In re Patent Application of)	
)	
Peter A. MILLER)	Group Art Unit: 2827
)	
Application No.: 09/839,151)	Examiner: Ishwarbhai B. Patel
)	
Filed: April 23, 2001)	Confirmation No.: 1629
)	
For: UHF GROUND INTERCONNECTS)

REQUEST FOR APPROVAL OF DRAWING CHANGES

FIGURE 1

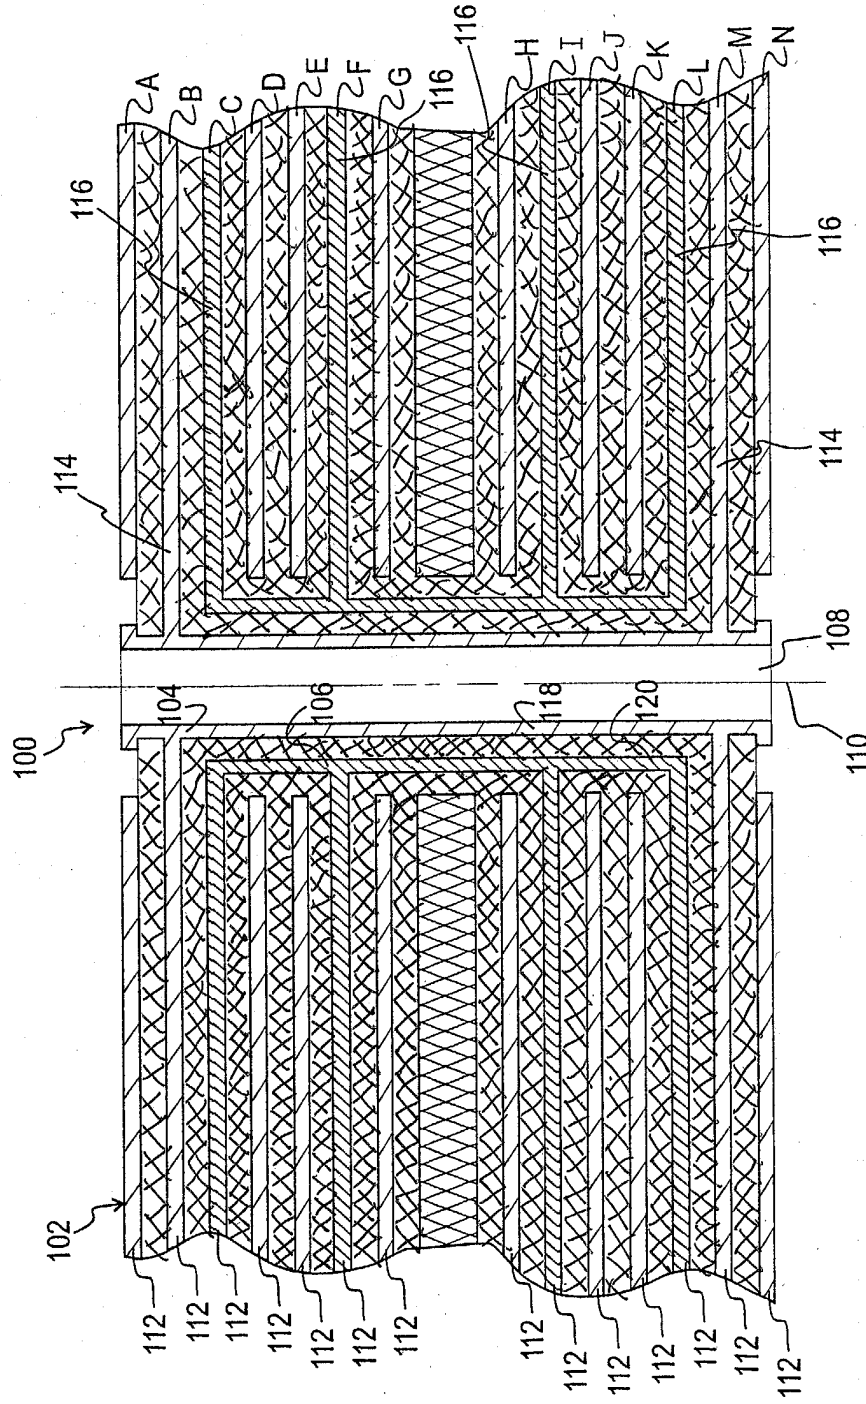
The Examiner's approval is respectfully requested for the proposed changes. Figure 1 has been changed by indicating in crosshatching all the parts that are shown in section. The addition indicates that the layers between the layers 112 are dielectric material.
